METROPOLITAN GOVERNMENT OF NASHVILLE AND DAVIDSON COUNTY

STAFF RECOMMENDATION
2601 Belmont Boulevard
July 17, 2013

Application: Partial Demolition; New Construction—Addition and Outbuilding; Setback reduction

GORDON/EWING RESIDENCE
2601 BELMONT BLVD.
NASHVILLE, TN 37212
SITE PLAN

GORDON/EWING RESIDENCE
2601 BELMONT BLVD.
NASHVILLE, TN 37212
NORTH ELEVATION

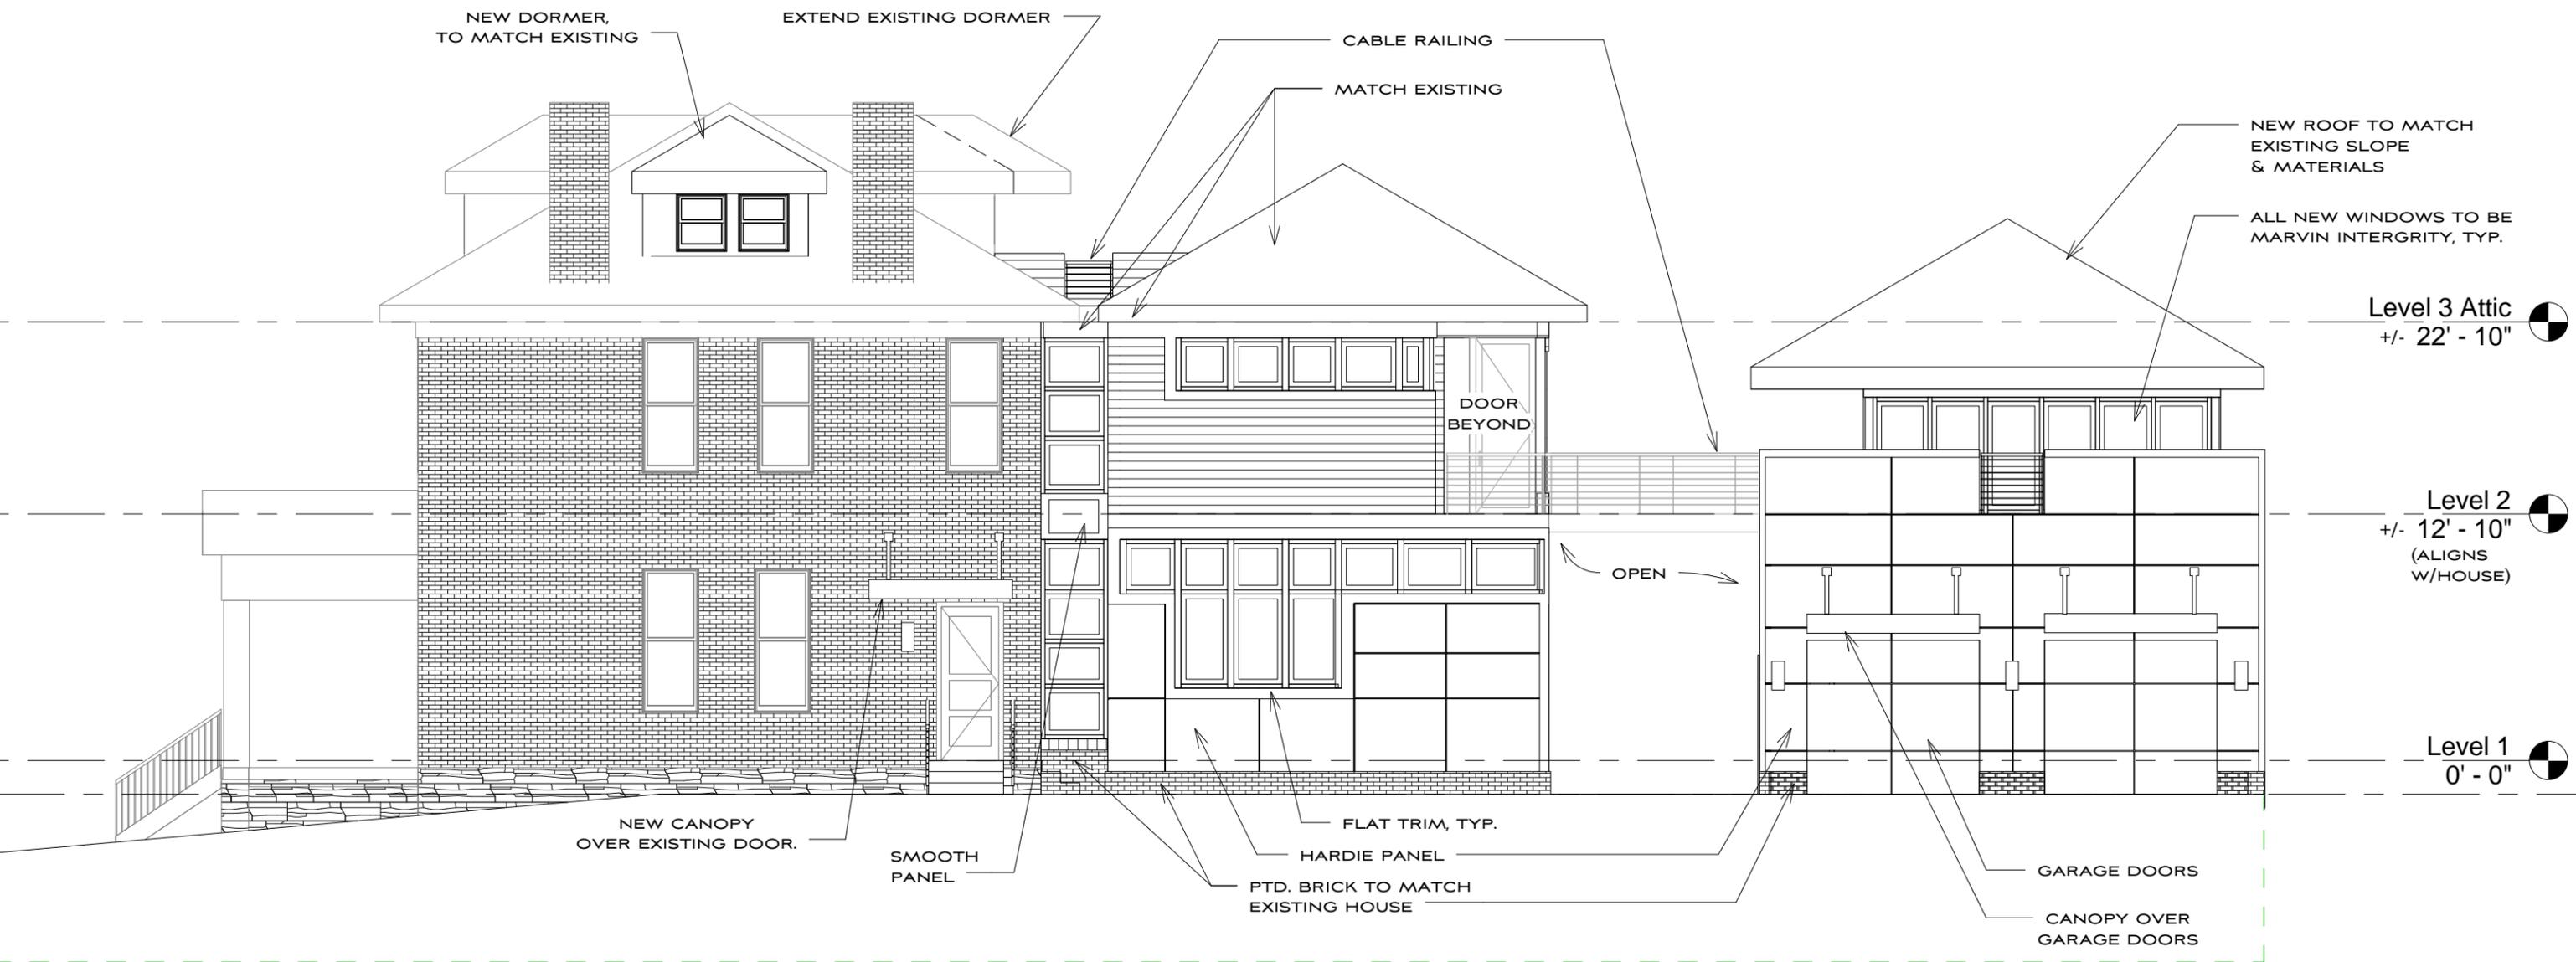
Figure 5. The historic house’s north façade facing Sweetbriar Avenue

Dormers: A new side dormer is proposed for the north/Sweetbriar Avenue façade of the historic house. The new dormer will match the width, height, location, and roof pitch and form of the existing front dormer. The design guidelines recommend that side dormers be set two feet (2') below the ridge of the house and two feet (2') back from the house's side wall. The side dormer will sit at least two feet (2') off the sidewall of the house. However, it is set approximately six inches (6") below the ridge of the house. Because it matches the location of the existing front dormer, staff finds the distance from the ridge of the roof to be appropriate. The side dormer will have a hipped roof with a roof slope of approximately 6/12, matching the roof form and slope of the existing house and existing front dormer.

SOUTH ELEVATION

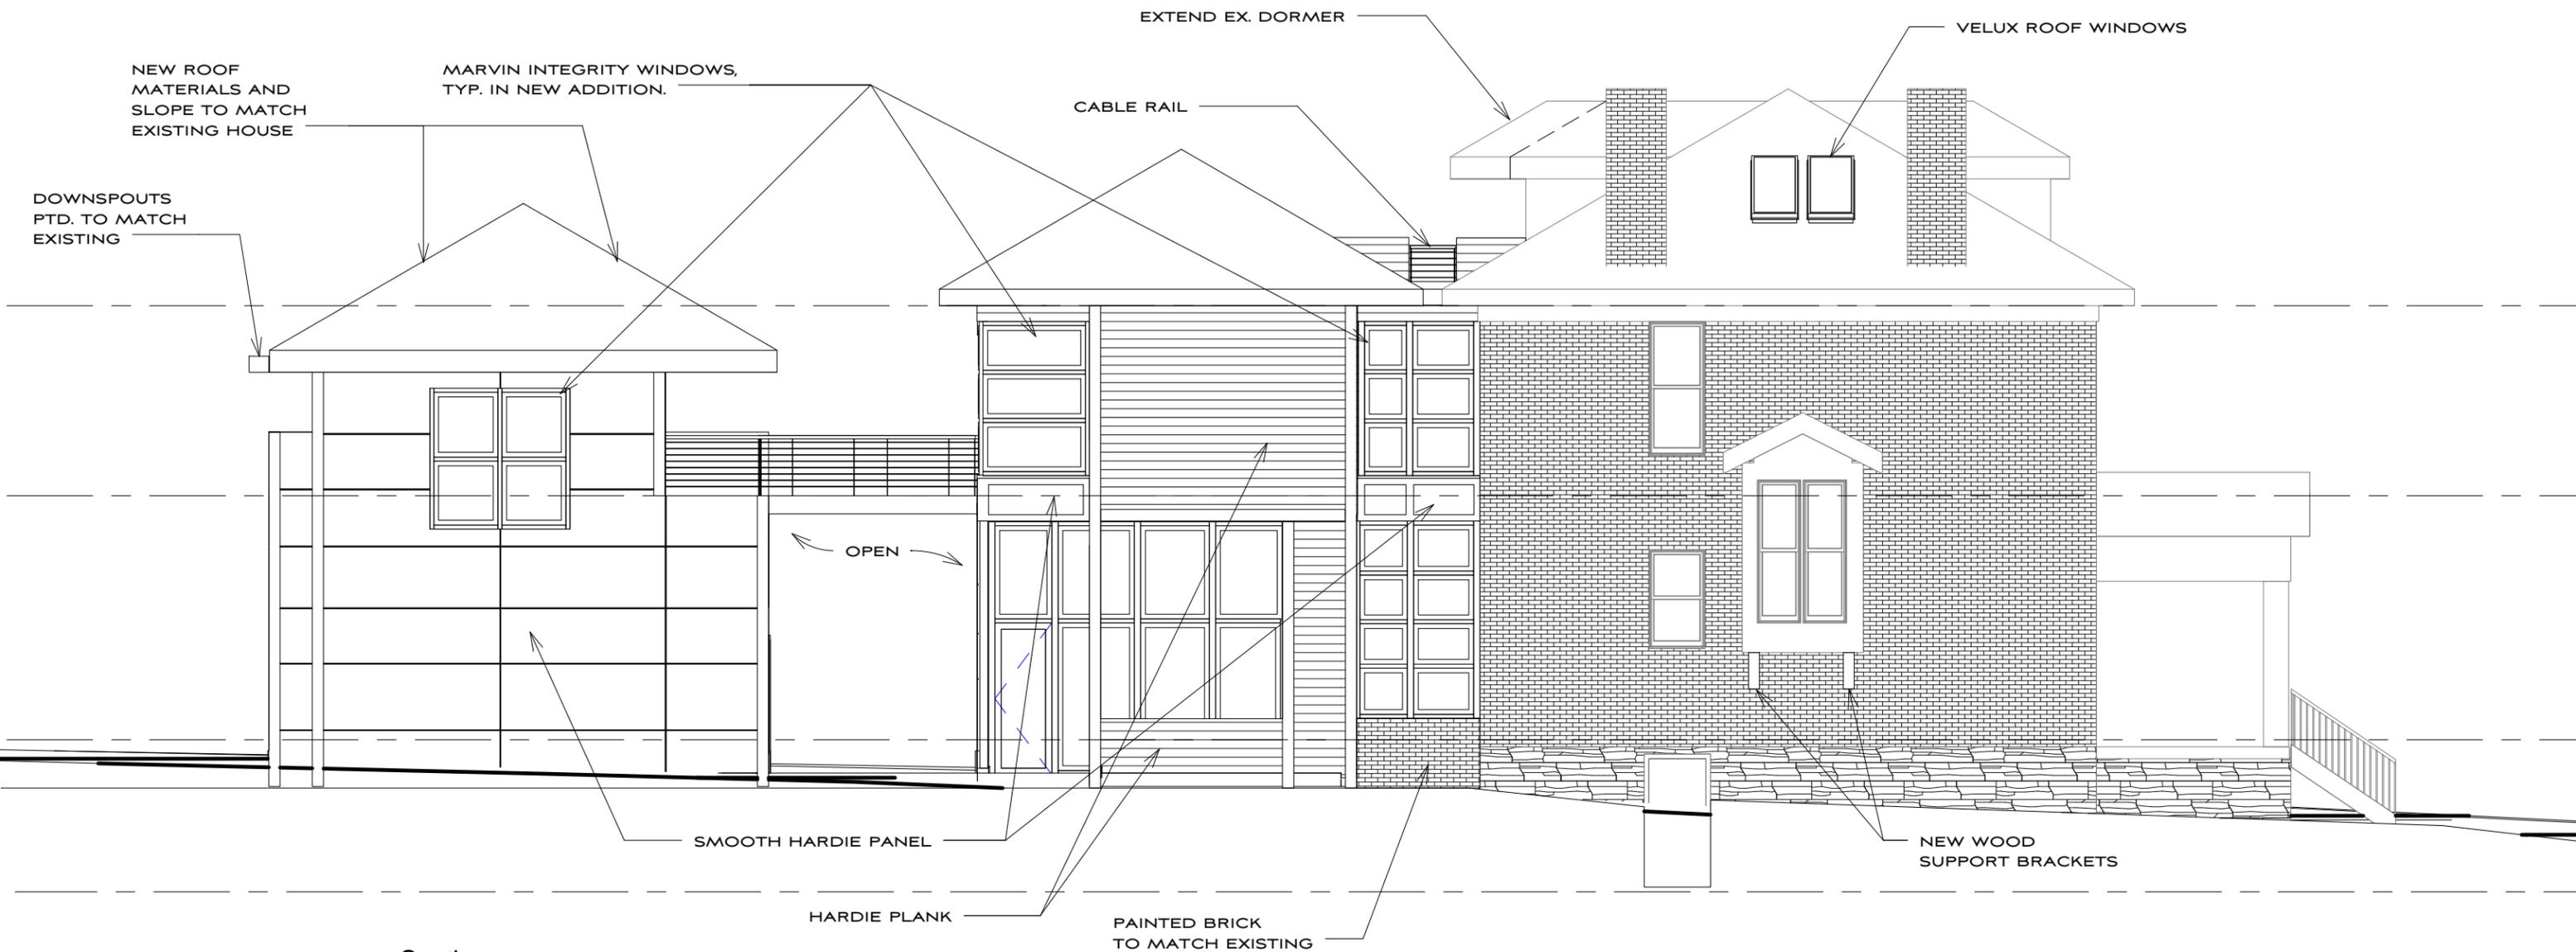
On the south elevation, the applicant is proposing to add two skylights. Staff finds that the scale and location of these skylights will not negatively affect the historic house and finds that they meet the design guidelines. The applicant is also proposing to extend the roof overhang of the existing rear dormer, but not alter the location, width, or height of the dormer. The overhang will provide a roof terrace connecting the existing house to the addition. Staff finds the extension of the rear dormer roof to be appropriate.

DEMOLITION PLAN - MAIN
 LEVEL

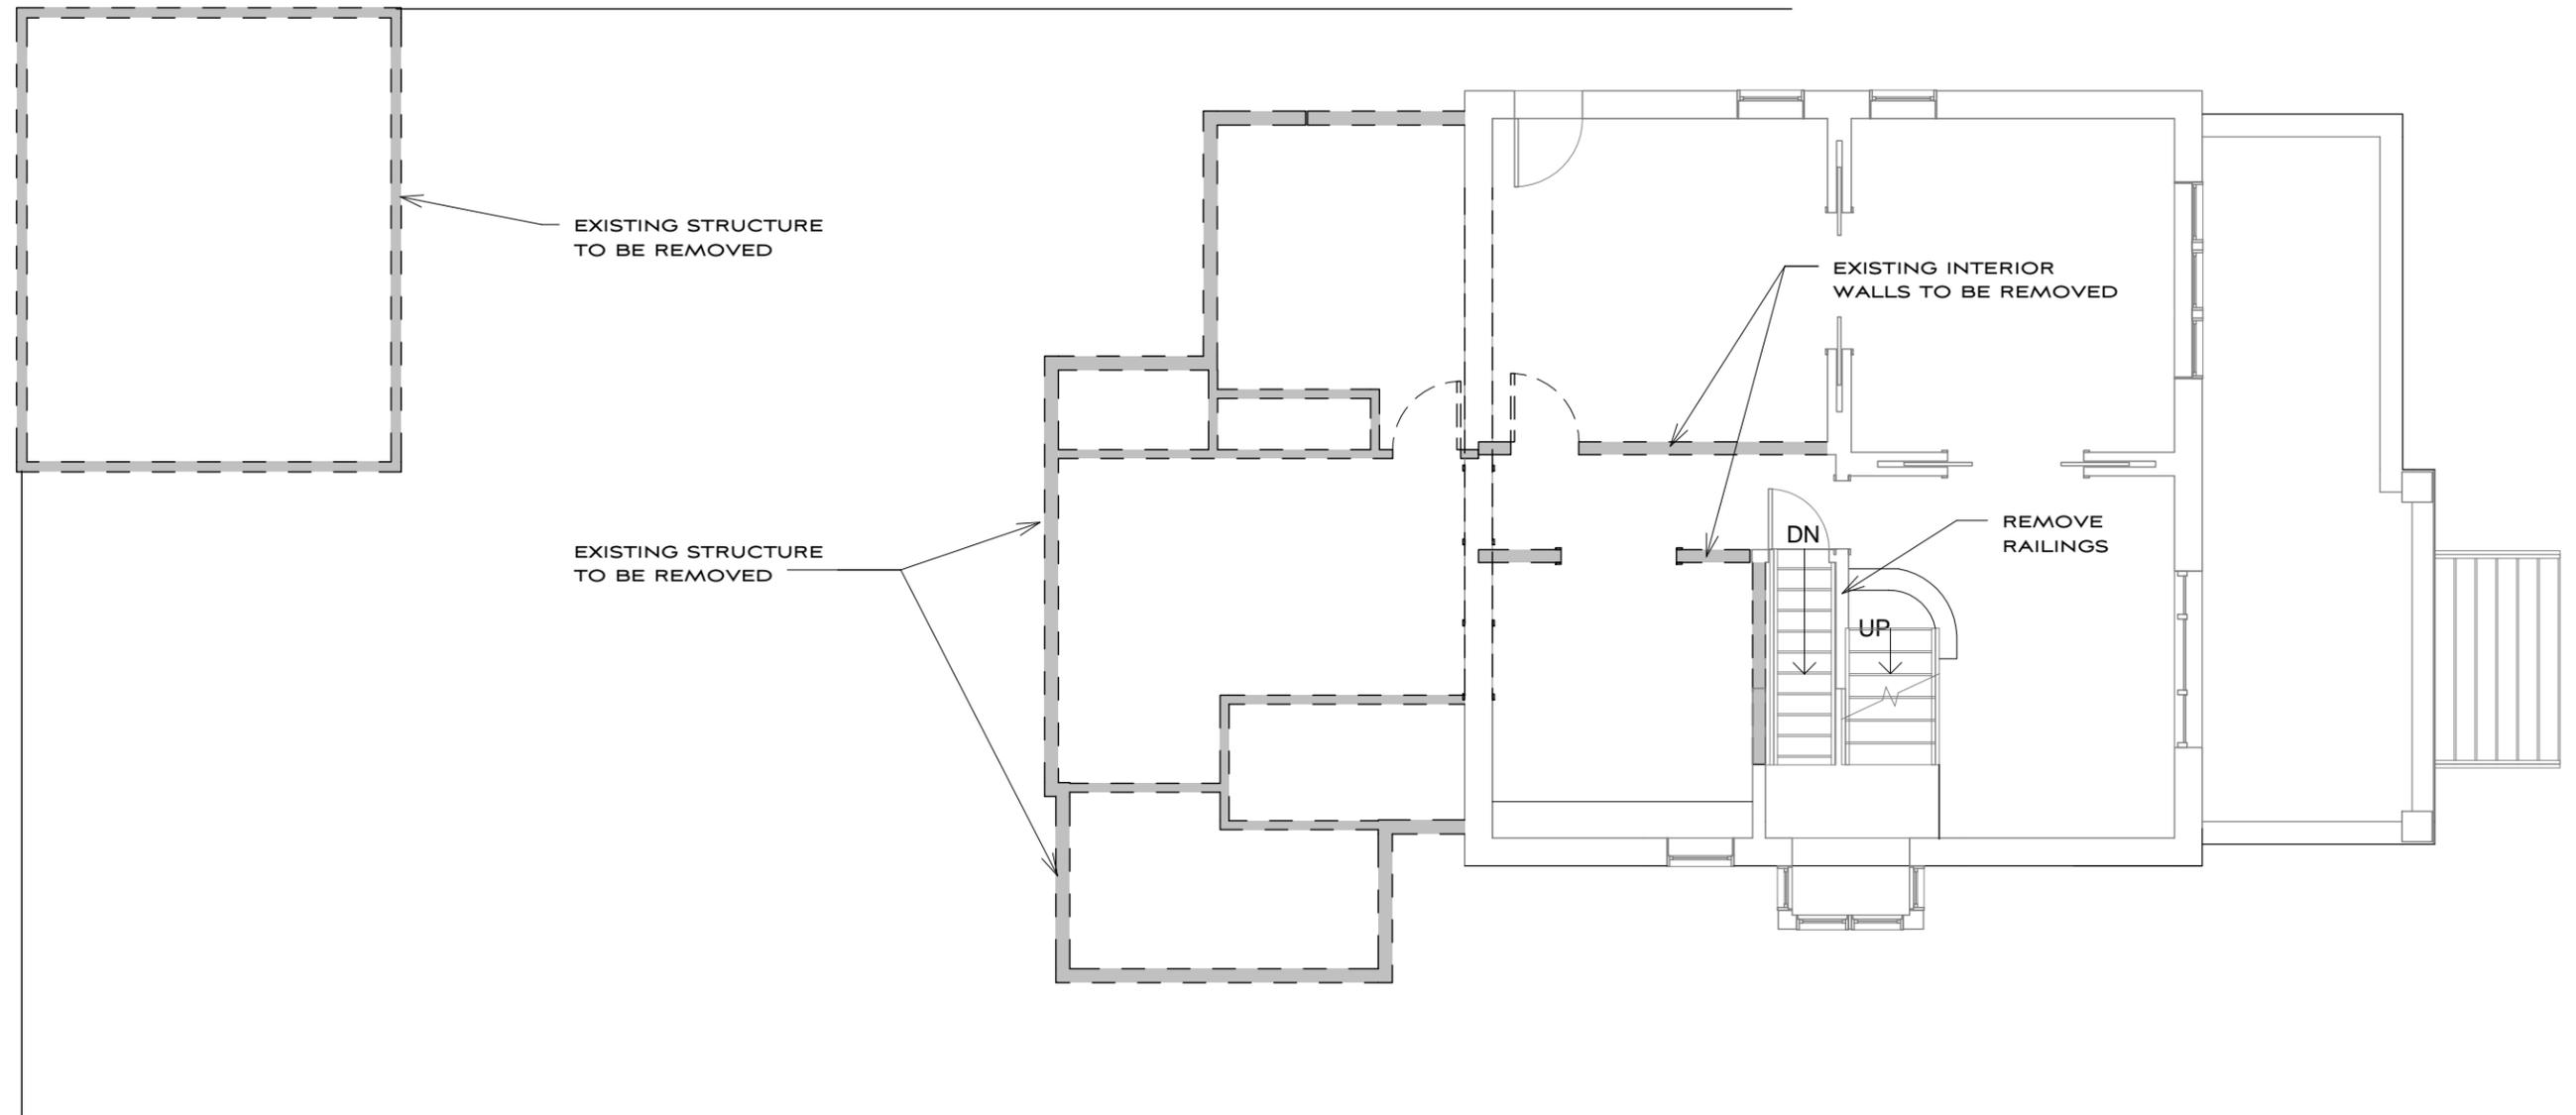
Partial Demolition: The applicant is proposing to demolish an existing addition and an existing outbuilding (see Figures 2 – 4). Staff finds that the existing addition at the rear does not contribute to the historic character of the house and the district. It extends beyond the wall of the historic house on the south side, and its removal will result in a more historically appropriate visual effect. Likewise, the outbuilding lacks historic and architectural interest. Staff therefore finds that the demolition of the existing addition and the outbuilding meets Section III.B.2. of the *Belmont-Hillsboro Neighborhood Conservation Zoning Overlay: Handbook and Design Guidelines*.
